Access Compliance Report

Public Rights-of-Way

Intersection ID: 10029891	Main Street: LADLEY_CT	Cross Street: N/A	Location:	N
ADA ID: F984D724D8F2	Ramp Type: PerpDiag	Initial Pass/Fail: Pass	Overall Compliance: No	Severity Score: 5
Codes/Mitigation Info/Possible Solution		Field Measurements/Component Compliance

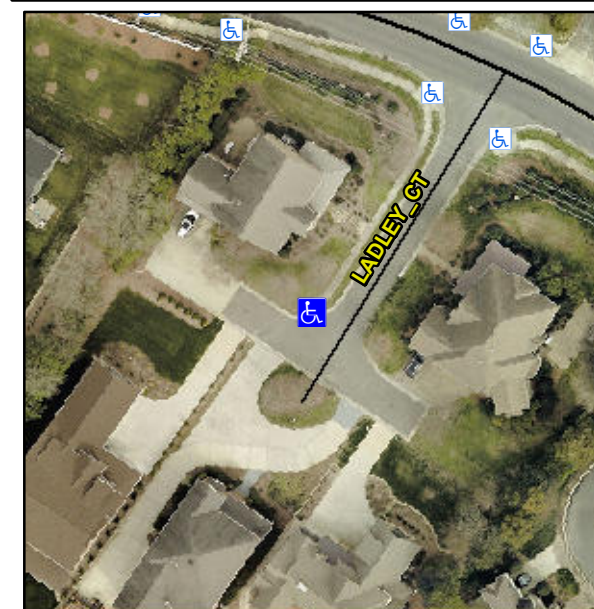
Not Found, R304.2.1, R304.2.2-Perp, R304.3.2-Para, R304.5.4, R304.5.3

Remove & Replace Curb Ramp With Two New Directional Ramps or Equivalent. Remove & Replace Gutter.
